Pentium[®] Pro Processor Specification Update

Release Date: December 1998

Order Number: 242689-034

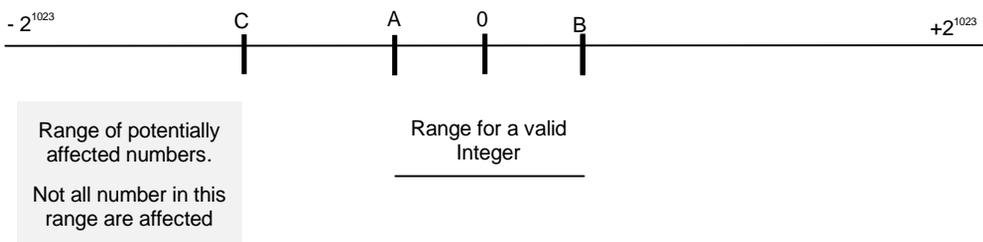
PROBLEM: On certain, large, negative, floating-point operands, and only in three of the four possible processor rounding modes, the instructions FIST[P] m16int and FIST[P] m32int do not detect that the operand is so large that it will not fit into the target data size. As a consequence, the expected Invalid Operation exception response for this situation is not correctly provided, nor is the Invalid Operation flag set in the Floating Point status word as specified in the *Intel Architecture Programmers Reference Manual, Volume 2*. Under the failing conditions, noted below, the precision exception (#PE) flag will also be incorrectly set. The erratum occurs only when all of the following conditions are met:

B. Expected Response

The expected processor response when the invalid operation exception is *masked* is:

- Return the MAXNEG value (8000h for FIST16 & 80000000h for FIST32) to memory.
- The IE (Invalid Operation) bit in the Floating Point status word is *set* to flag the overflow.
- The PE (precision error) bit the Floating Point status word is *not set*.

The expected processor response when the invalid operation exception is *unmasked* is:

- Do not return a result to memory. Keep the original operand intact on the stack.
- The IE (Invalid Operation) bit in the Floating Point status word is *set* to flag the overflow.

Figure 4-3. Stack Switch on a Call to a Different Privilege Level

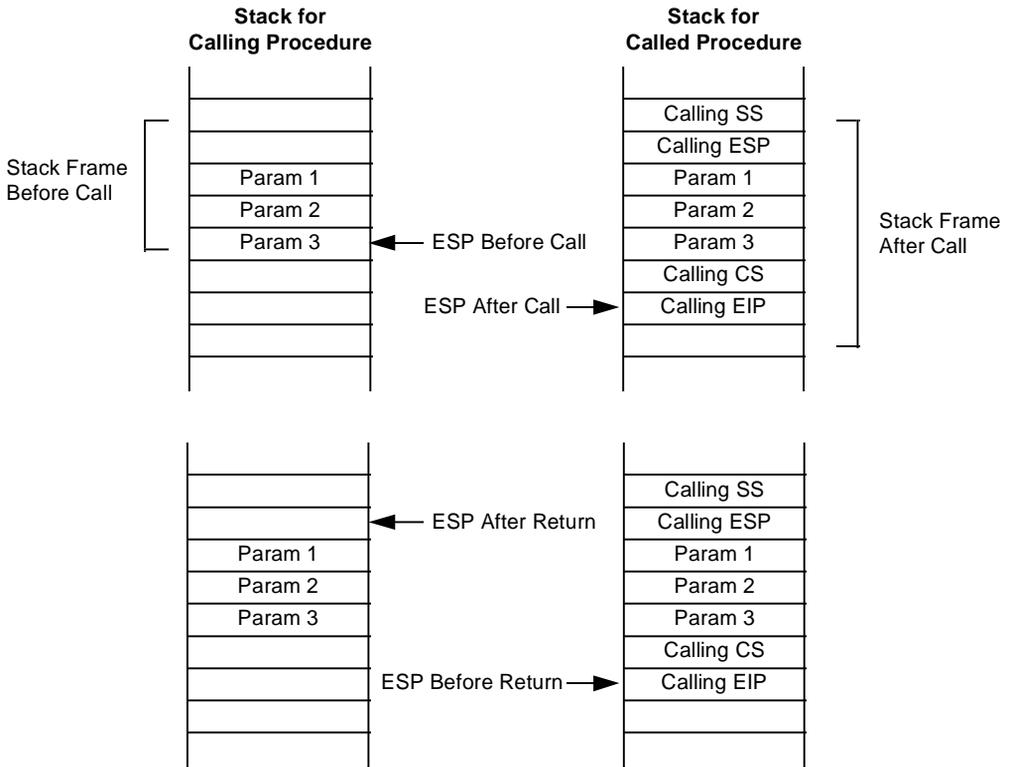
4.3.6 CALL and RET Operation Between Privilege Levels

When making a call to a more privileged protection level, the processor does the following (see Figure 4-3):

1. Performs an access rights check (privilege check).
2. Temporarily saves (internally) the current contents of the SS, ESP, CS, and EIP registers.
3. Loads the segment selector and stack pointer for the new stack (that is, the stack for the privilege level being called) from the TSS into the SS and ESP registers and switches to the new stack.
4. Pushes the temporarily saved SS and ESP values for the calling procedure's stack onto the new stack.
5. Copies the parameters from the calling procedure's stack to the new stack. (A value in the call gate descriptor determines how many parameters to copy to the new stack.)
6. Pushes the temporarily saved CS and EIP values for the calling procedure to the new stack.
7. Loads the segment selector for the new code segment and the new instruction pointer from the call gate into the CS and EIP registers, respectively.

Begins execution of the called procedure at the new privilege level.

4. Restores the SS and ESP registers to their values prior to the call, which causes a switch back to the stack of the calling procedure.
5. (If the RET instruction has an optional n argument.) Increments the stack pointer by the number of bytes specified with the n operand to release parameters from the stack (see explanation in step 3).

Note: On a return, parameters are released on both stacks if the correct value is given for the *n* operand in the RET *n* instruction.

Figure 4-4. Stack Usage on Transfers to Interrupt and Exception Handling Routines

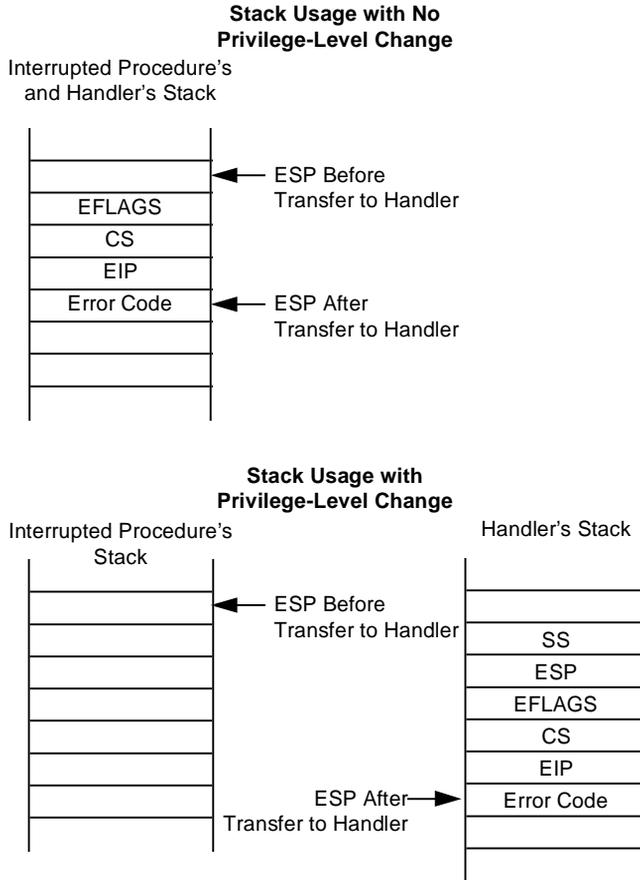
If no stack switch occurs, the processor does the following when calling an interrupt or exception handler (see Figure 44):

1. Performs a privilege check.
2. Restores the CS and EIP registers to their values prior to the interrupt or exception.
3. Restores the EFLAGS register.

4. Restores the SS and ESP registers to their values prior to the interrupt or exception, resulting in a stack switch back to the stack of the interrupted procedure.
5. Resumes execution of the interrupted procedure.
